CHESTER CYCLING CAMPAIGN

CCC report on A56 Corridor

This note essentially covers the A56 from the 'SuperTrees' roundabout to the M56 roundabout. We note the wider area to be covered in the Mott MacDonald/ Broadway Malyan study and some observations will be made that are outside the immediate A56 corridor but within their kite-shaped area. We will address at least some of the issues in other parts of the 'kite' in later iterations of this note.

1. The A56 Hoole Way from the 'SuperTrees' gateway roundabout to the traffic lights at Black Diamond St.

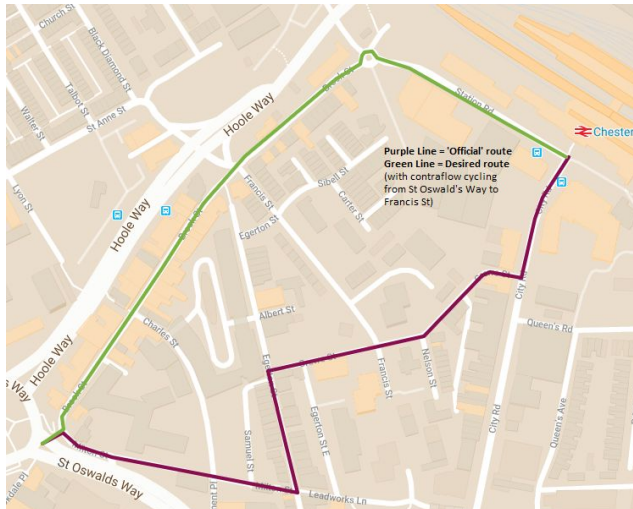
This is fundamentally unsafe for cyclists. Specifically, if travelling from Frodsham St., there is a requirement to cross two traffic lanes which may not be understood by motorists travelling up to the Fountains Roundabout:-

There is also danger from motors travelling down from the Fountains roundabout and then up Hoole Way (see position of white car in picture below) – many do not think that they should give way to (or even see) a cyclist who is already on the roundabout in the nearside lane.

Whilst there is a reasonable crossing from Brookdale Place to Brook St, the 'town end' of this street is currently one way for all traffic. Cyclists leaving the City technically have to divert via Mill Rd and Egerton St in order to access the Black Diamond St traffic lights and Hoole Bridge (see picture). It is a longer route and not obvious although it is signed. Because of speed bumps and carriageway pinch point constrictions, these streets are neither particularly safe nor pleasant to cycle:-

The solution should be to make the 'town end' of Brook St (i.e. from St Oswald's Way to Francis St) two-way for cycles. The pavement is wide enough at the end nearest St Oswald's Way for a (segregated) Shared Use Path (SUP)*, but there would be a need to widen the path on the lower part down to Francis St and to restrict parking to only the east side of the road. Though illegal, people do currently stop and park on the west side pavement on this stretch and some element of prevention would need to be designed-in here.

2. The Black Diamond St/ Hoole Way traffic lights junction.

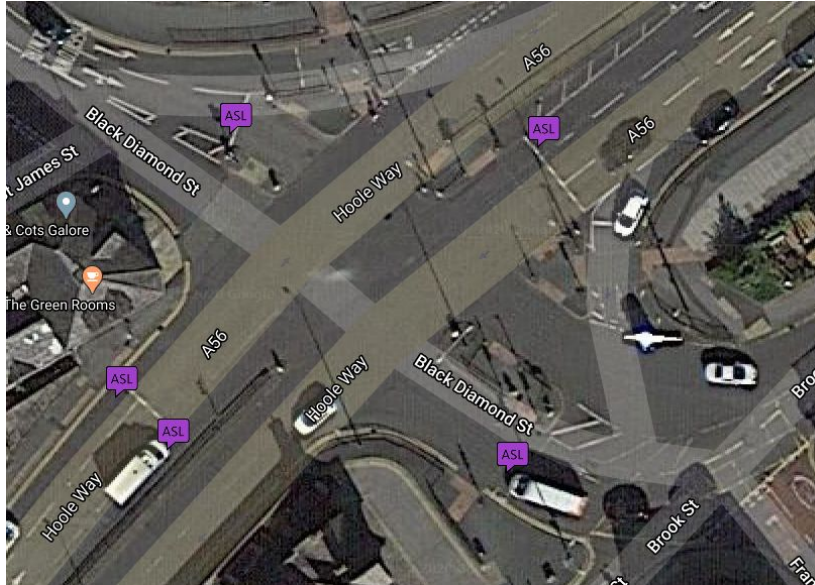
- a. The signage at the bottom of the street is non-compliant and the signs are mutually exclusive.

The round sign is one indicating cycles only. It should be rectangular if the intention is to allow the use of the road by motorised traffic as well.

- b. An Advanced Stop Line (ASL) is required for cyclists cycling from the east side of Black Diamond St onto Hoole Bridge, given the width of the junction and the rise onto the bridge. ASLs should also be considered at the other points indicated:-

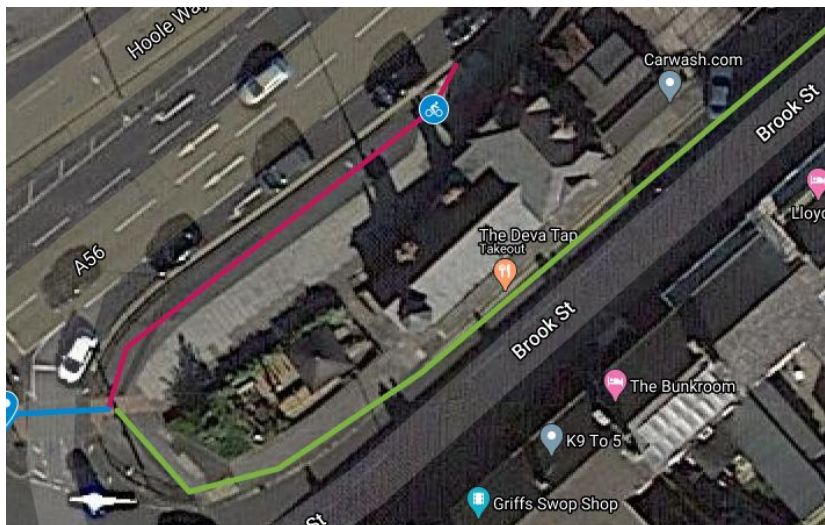
- c. There is a small section of cycle track on the city bound pavement to the lights (in Red in the picture):-

This is useful, but the ground should be marked to inform pedestrians using the pavement in both directions that it is shared use (or it could be segregated^{1,2} – it is wide enough - A simple line on the ground could be used to make the ride hand side cycle only.)

Ideally, it would also extend into the ‘Station end’ of Brook St (marked in Green) to at least the mini-roundabout to aid access to the station. The pavement in front of the car-wash and existing commercial properties is rather narrow – ideally, even if only when this area is redeveloped, the extra width could be acquired to facilitate this. Again, with ref to latest guidelines^{1,2}, a segregated track would be preferable if sufficient width could be provided.

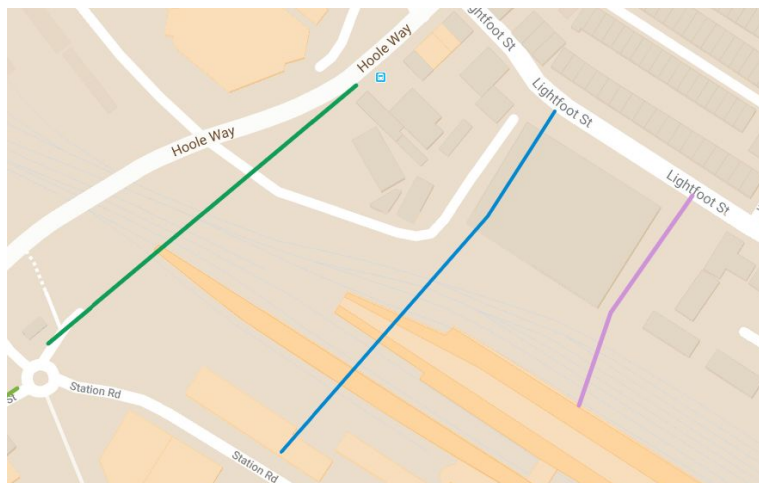
To some extent, the potential for improvements in this area depends on what arrangements are made for a new pedestrian/ cycle bridge over the Railway – preferably it would be constructed to run from the Bus stop area to the mini-roundabout (in green on map) but another route (e.g. the blue) might prove more feasible (Lightfoot St to Station Road):-

In addition a bridge from Lightfoot St to the existing station bridge (purple above) appears easy to realise in view of the proposed addition of new platforms in place of the existing sidings. If this could also be made cycle-able, this would aid passengers who intend to travel by train with cycles. We do not see this as a substitute for a route which will deliver non-train customer users to Station Road rather than to the track side of the station concourse. The green route above is the most direct and obvious one for cyclists and pedestrians.

3. The Railway Station Area

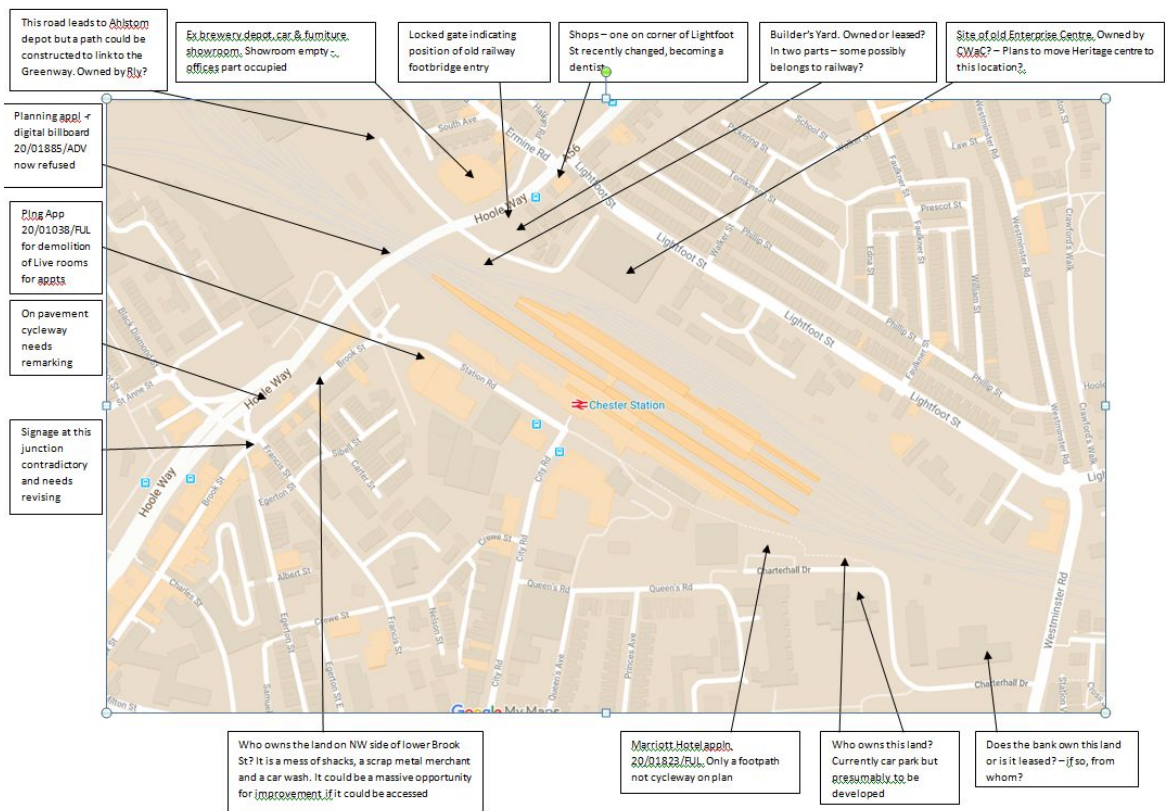
This area has essentially been covered in separate discussions and documents with 5th Studio, but the overall issues can be summarised by this map:-

In the light of the latest Government Guidance^{1, 2} (27-July-20), the route between the Railway Station and Westminster Road should have segregated pedestrian and cycling tracks rather than be an SUP. A comment to this effect has been posted by CCC with respect to the Marriott Courtyard planning application (20/01823/FUL).

4. Hoole Bridge

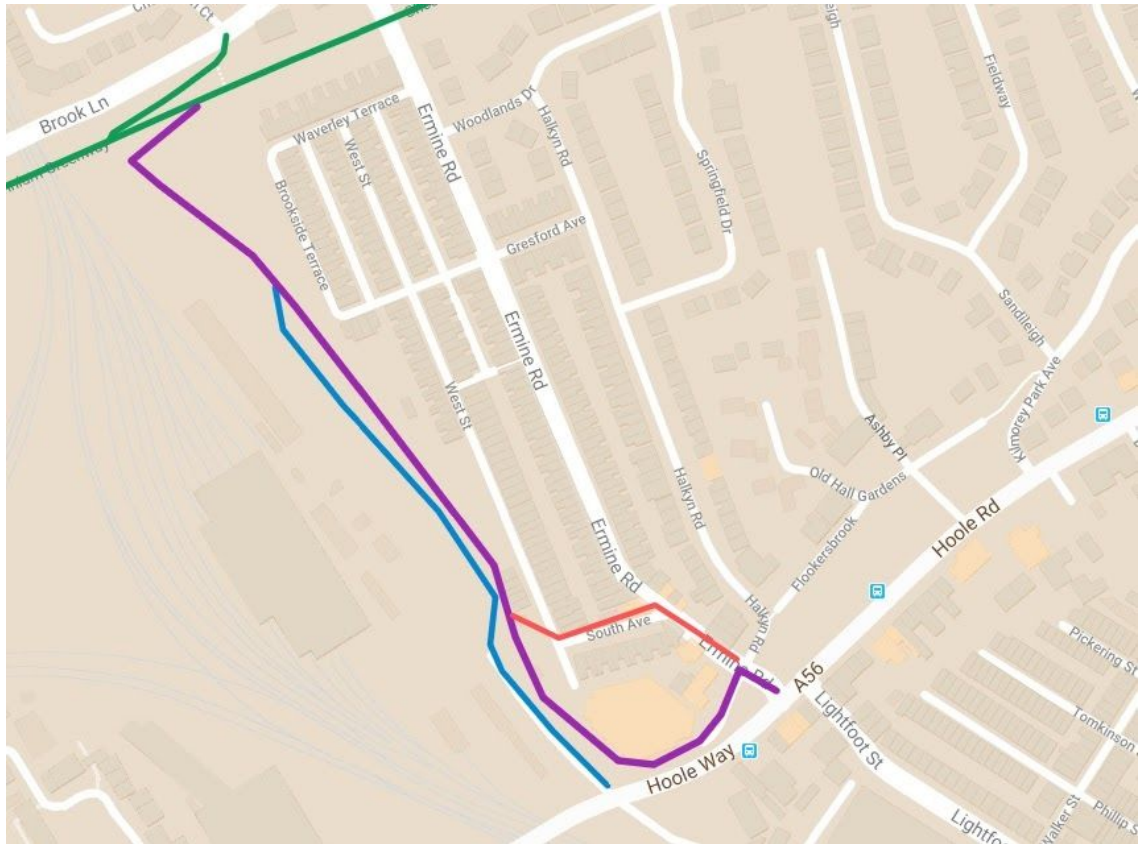
A minor improvement could be made by installing a dropped kerb in front of the vacant furniture warehouse. This would allow cyclists travelling from town to access Flookersbrook & Kilmorey Park Avenue more easily and safely and to avoid the Ermine Rd junction. The required dropped kerb is labelled "1". That marked "2" is already dropped.

9. Newton Lane Bridge

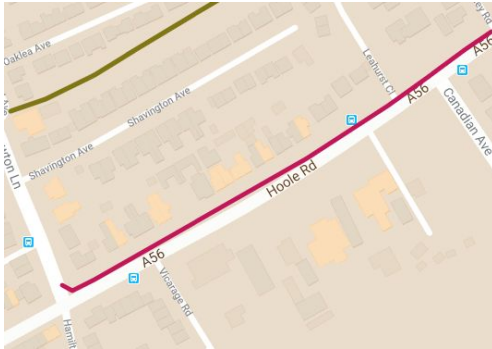
For cyclists travelling towards Hoole Road, the traffic lights can present some difficulty when having to make a start from ‘red’, owing to the rise over the bridge. The possibility of installing a one-way bypass to allow cyclists to avoid the stop is a potential solution to this problem (represented in purple in picture).

15. Fairfield Road to just beyond the United Reformed Church

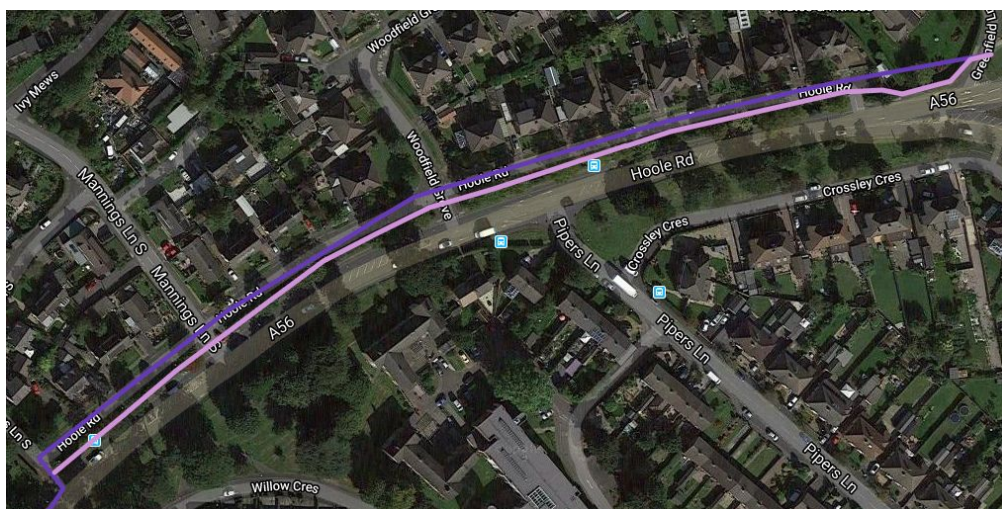
Again, there is no physical constraint on an extension of the cyclepath to this point. And again, pedestrians and cyclists should be given priority at Fairfield Road.

19. Hoole Road Roundabout (A56/A41)

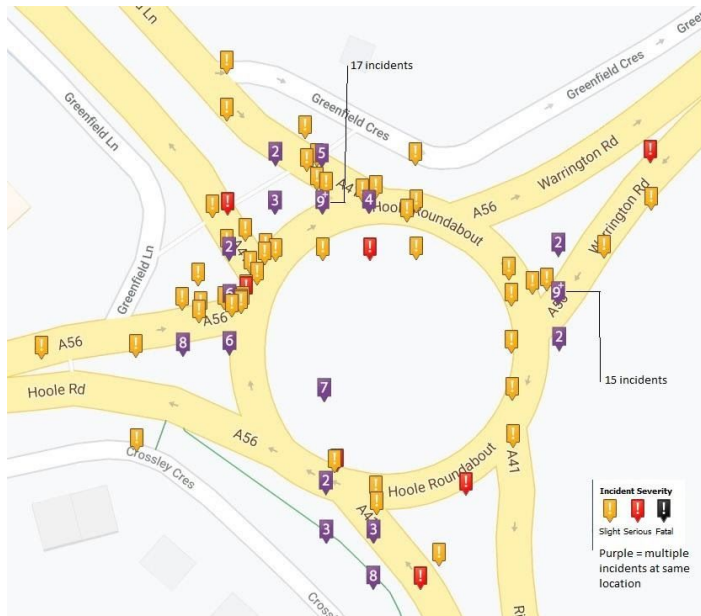
This needs a complete and bold re-think. It is dangerous for cyclists and pedestrians and there have been numerous car accidents. As the picture shows, there have been many accidents over the past 21 years³:-

It can become almost impossible to cross (even for cars) at peak periods. Crossing on the west side is particularly important for pupils from south of the roundabout attending Upton school.

A solution more favourable to sustainable means of travel should be the objective and any solution must also address the issues at the Green Lane/A41/ Guilden Sutton Lane junction – see pp 27 below. The Hilton Double Tree Hotel is difficult to access from the NW side of the road for non-motorists and this difficulty needs to be factored into any new arrangement.

21. Access to the Greenway from Greenfield Lane

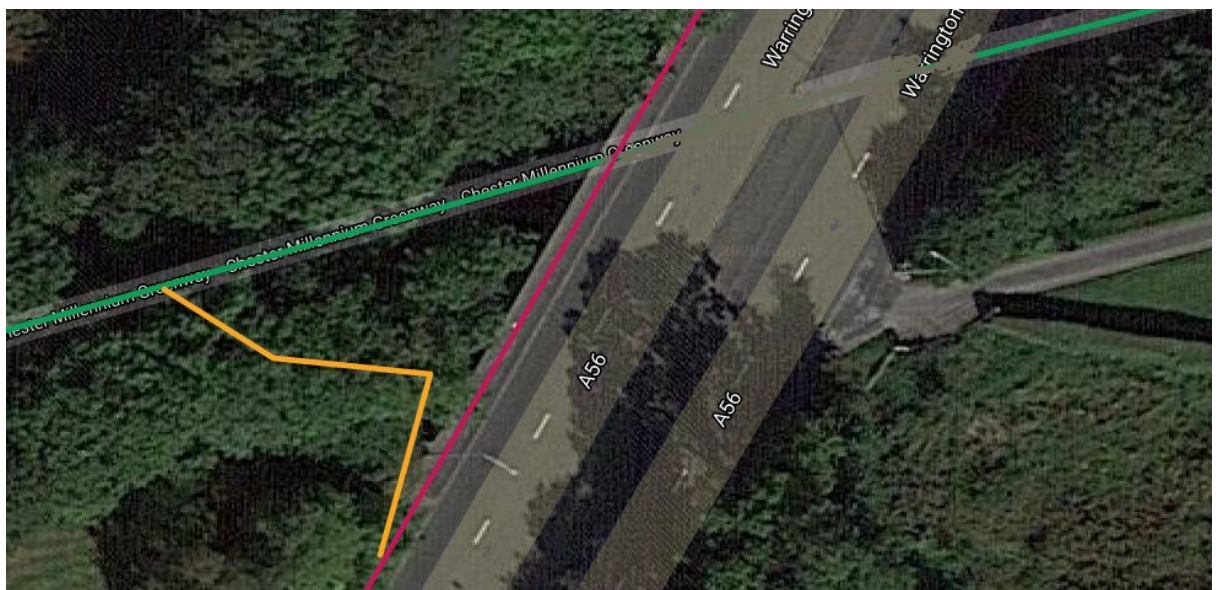
Whilst there is the existing access on the NE side of the A41, the possibility of an additional access from the SW (the 'town') side should be considered. There is room to install a straight ramp here.

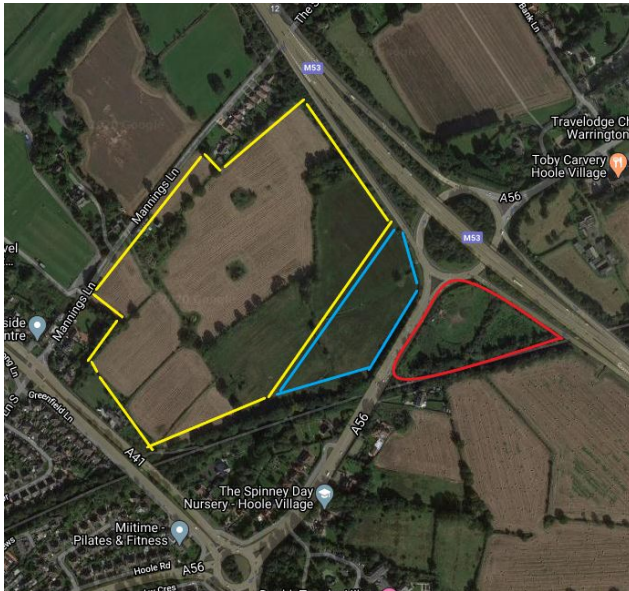
In the picture below, this land 'on the other side' is outlined in red which is about the same size as the Upton P&R site. The original documents regarding this proposed development are vague regarding the areas allocated for P&R vs housing, but along the lines of the area in

blue for the P&R in exchange for permission to build on the Greenbelt area bounded in yellow.

25. M53 to A41 Roundabout on A56 travelling towards the City

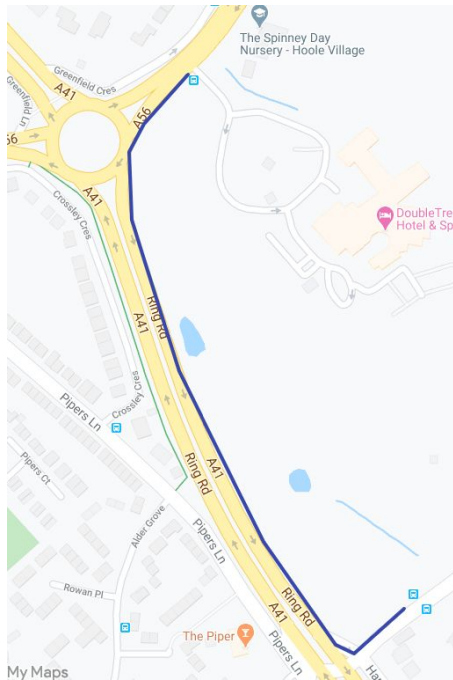
There is room for a segregated path or SUP on the pavement

27. The A41 Junction with Hoole Lane and Guilden Sutton Lane

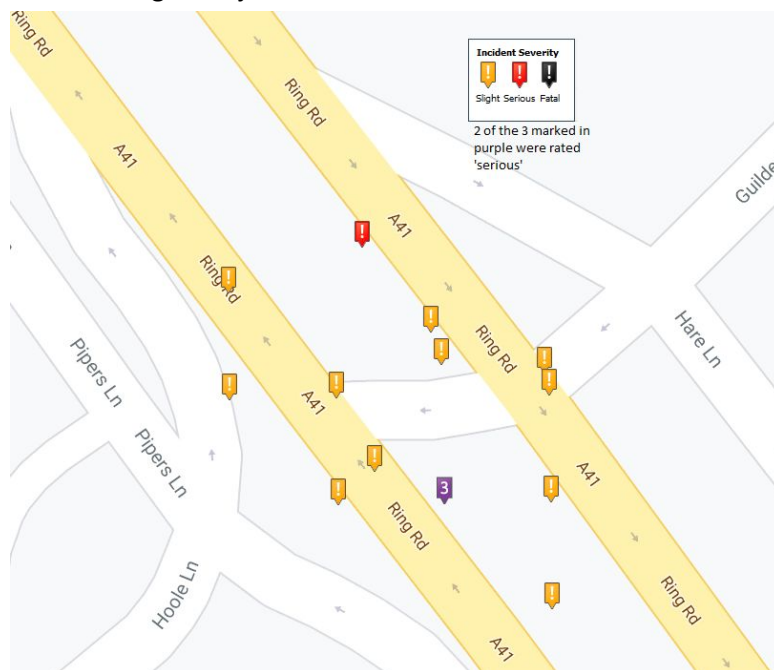
This is a dangerous junction and difficult to cross:-

Again, these are DfT records³ from the last 21 years but only include those incidents reported to the police and resulting in injury. The junction needs a complete re-think in association with revisions to the Hoole Road roundabout. Radical options such as a ‘Cyclops’ crossing or a Dutch style roundabout should be examined. To reiterate, any changes here should be done in tandem with those for the roundabout itself – see pp 19 above.

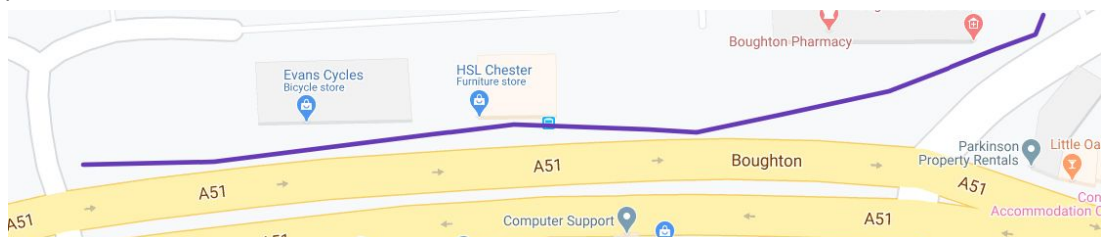
The entrance to the cycle path shown in the picture above is at right angles to the carriageway. Whilst this is well positioned for those coming from Long Lane, it is difficult (particularly for those with trikes, tandems or cargo bikes) to join from Plas Newton Lane. The entrance is only about 2 cars back in queuing traffic waiting for the lights to change and another access point from the junction with the sports club would be useful, enabling bikes to leave the traffic queue earlier and more safely.

D. A51 Shropshire Union canal bridge, Vicars Cross Rd

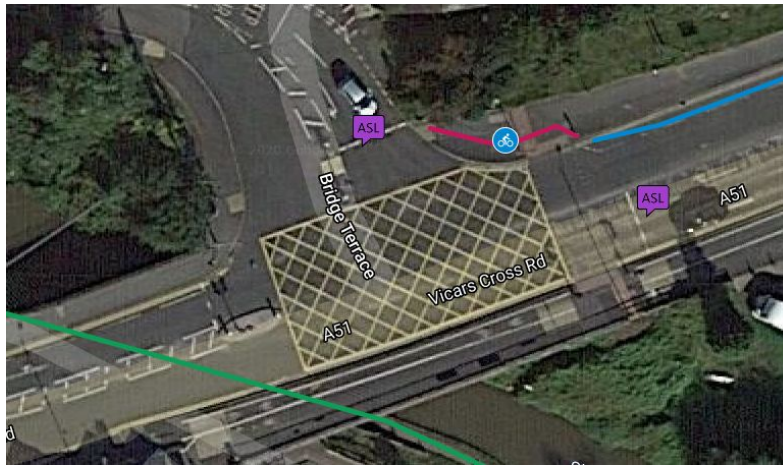
Some deficiencies in the current configuration are noted below for the record but may have already been addressed as part of the above work:- Whilst there is a cycle bypass in-bound for the city cyclists, there is a need for an ASL for those wishing to turn right to Aldi and the other stores. There is also a need for an ASL for cyclists exiting the estate and turning right towards town, as the road is on a slope which necessitates extra time for cycles..

There is an existing stretch of pavement SUP, the signage for which is currently confusing as it is not clearly marked that it ends as soon as it is round the corner. The sign, which presumably is for motorists' information, may be misread by cyclists as an indication that it continues on the pavement despite the adjacent carriageway lane:-
